**SUBJECT: NEW VEHICLE DEMONSTRATION / DELIVERY HOLD -
 Safety Recall 18S32 - *Supplement #2***

Certain 2012-2018 Model Year Focus Vehicles Equipped With 2.0L GDI and GTDI
 Engines
 Fuel Tank Deformation

New! REASON FOR THIS SUPPLEMENT

FIGURE 1

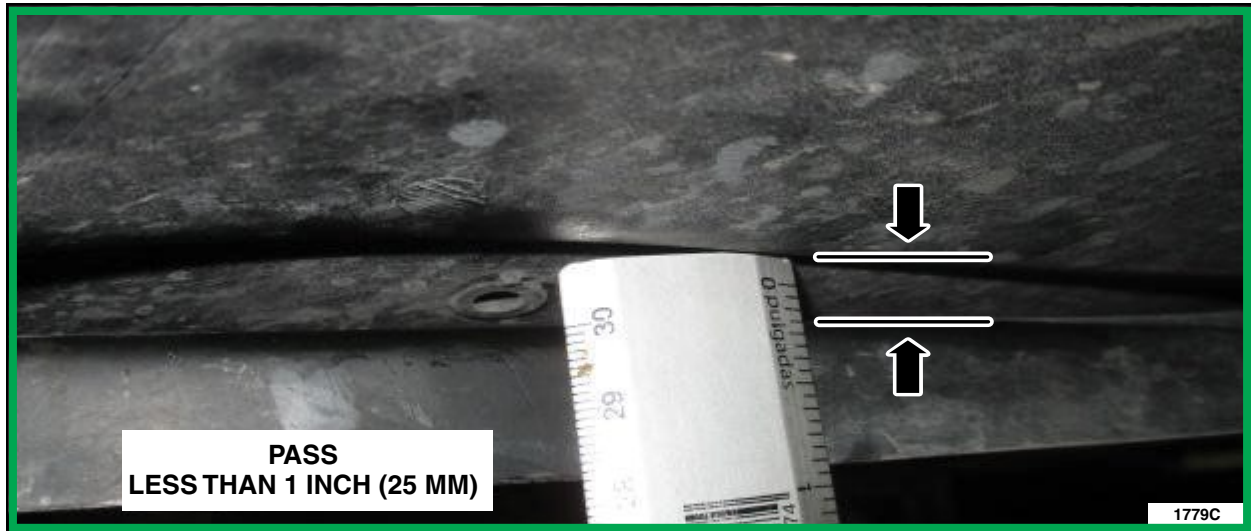
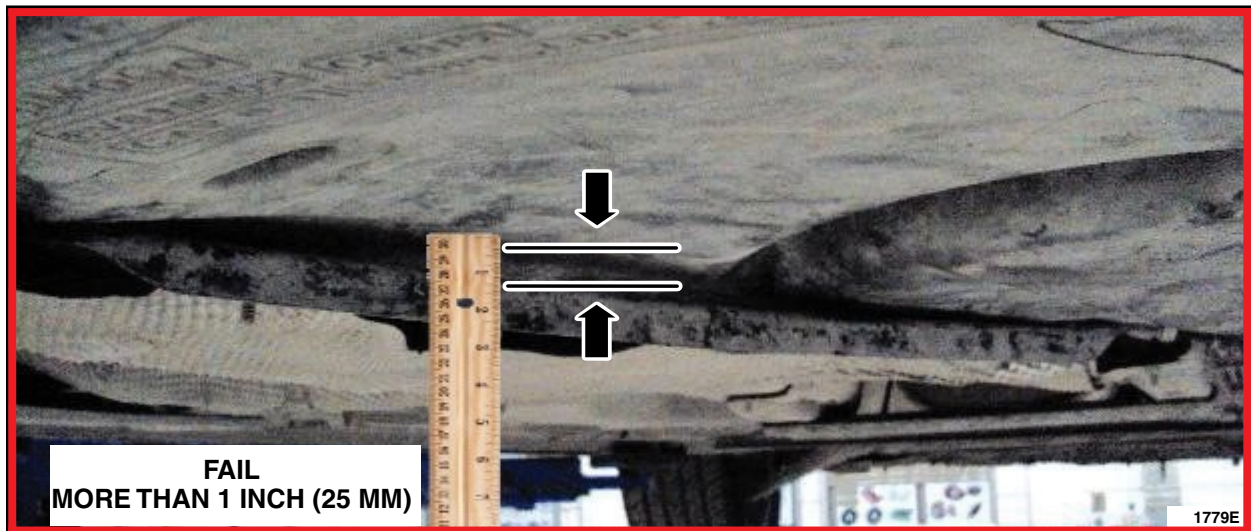
7. Review the pass/fail photos in Figures 1 and 2. Inspect the fuel tank. Is the bottom of the fuel tank deformed more than 25 mm (1 in) upward?. If the tank has failed, capture high quality digital images of the deformed tank before replacing. See Figures 3 - 6 for examples of non acceptable and acceptable photos.
- Pass* - Repair is complete.
 - Fail* - *Review new digital image submission requirements before submitting vin-specific part order to SSSC.*
 - Replace the fuel tank and fuel delivery module. Please follow the WSM procedures in Section 310- 01.

FIGURE 6

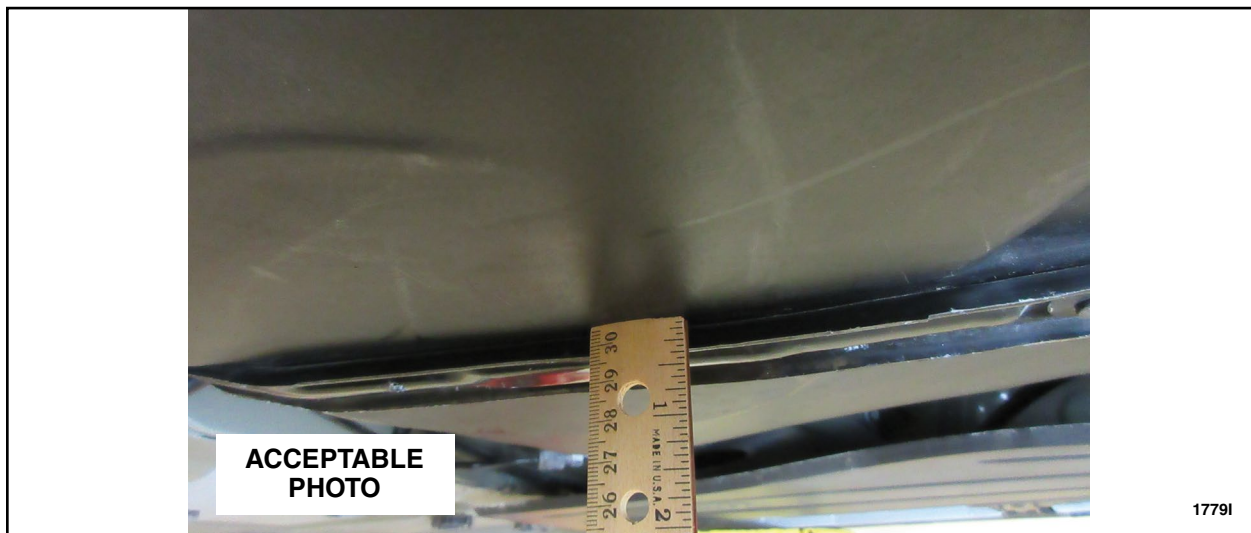
- *Submit a minimum of three images clearly showing where the fuel tank is deformed, including the following requirements:*
 1. *A minimum of 25mm or 1-inch upward gap between the bottom of the fuel tank and the fuel tank straps or fuel tank reinforcement.*
 2. *A tape measure or ruler must be included showing the 1" gap.*
 3. *A VIN tag photo for vehicle*
- *Images should be focused and have proper lighting. Submitting poor quality images may result in a potential chargeback of 18S32ZZ.*
